BIDDERS BULLETIN

PROJECT: North Park Elementary School – 2012 Addition
and Renovation
Broken Bow, Nebraska

BB-1

DATE ISSUED: March 21, 2012

DATE: March 19, 2012
DRAWING: A801.1
FROM SHEET: A801

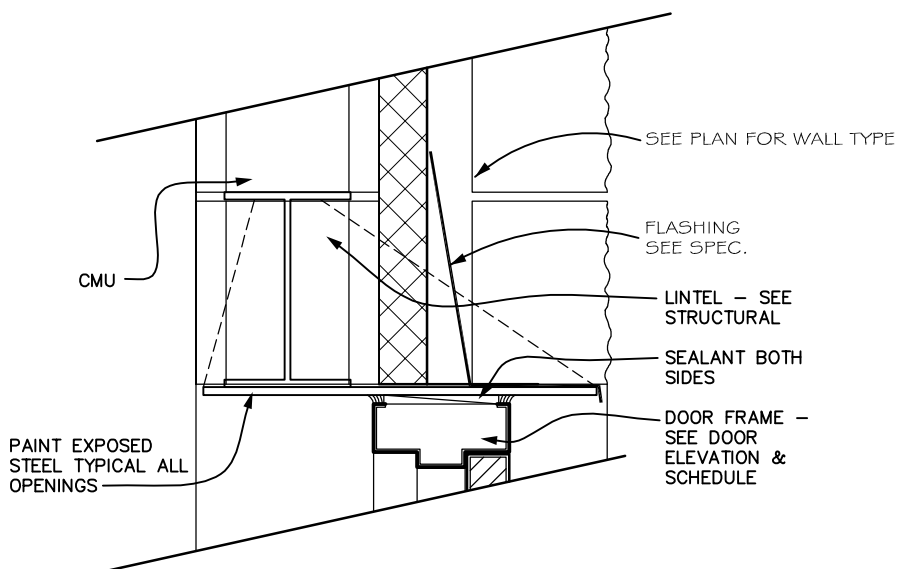
- 2) Revise doors 147cc and 147cd head detail to be D1/A801.1
- 3) Revise doors 143c, 147ca, 147cb, 147cc and 147cd door frame to be "HM-2"

BB-1, ITEM #26: Drawing Sheet A801 – See Supplemental Sheet A801.1

- 1) Add detail A801.1
